Groundwater Transfer Review Summary Form

Transfer/PA # T- 14854

Application: T-14854

Applicant Name: Carlton Nursery Co. LLC

Map

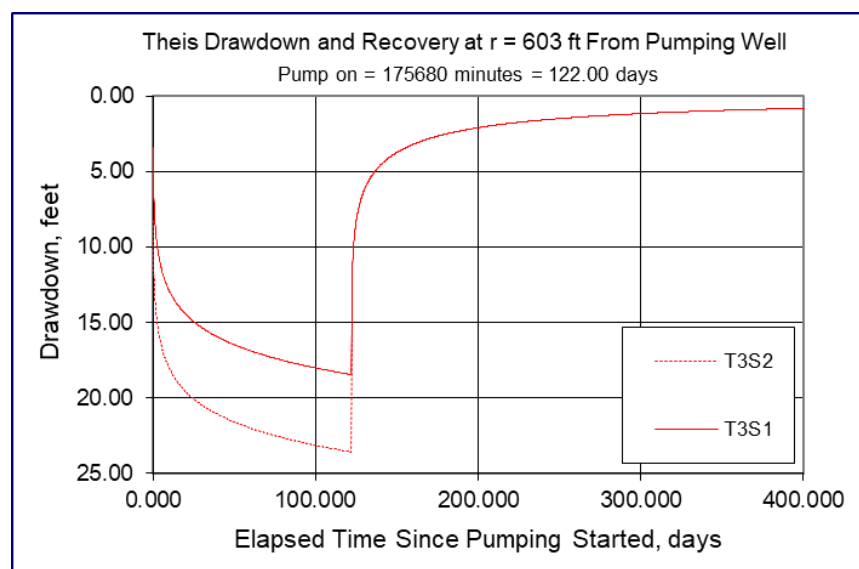
☒ Yes ☐ No Comments: The APOA Unionvale Well 3 (YAMH 59179) is closer to **MARI 2888** an authorized POA under Certificate 96102 with priority date 7/14/1959 and **YAMH 6444**. The reduced intervening distance is anticipated to increase the interference with **MARI 2888** and **YAMH 6444**.

☒ Yes ☐ No Comments: The APOA Unionvale Well 3 (YAMH 59179) is closer to Lambert Slough than the authorized POAs. The reduced intervening distance is anticipated to increase the interference with Lambert Slough.
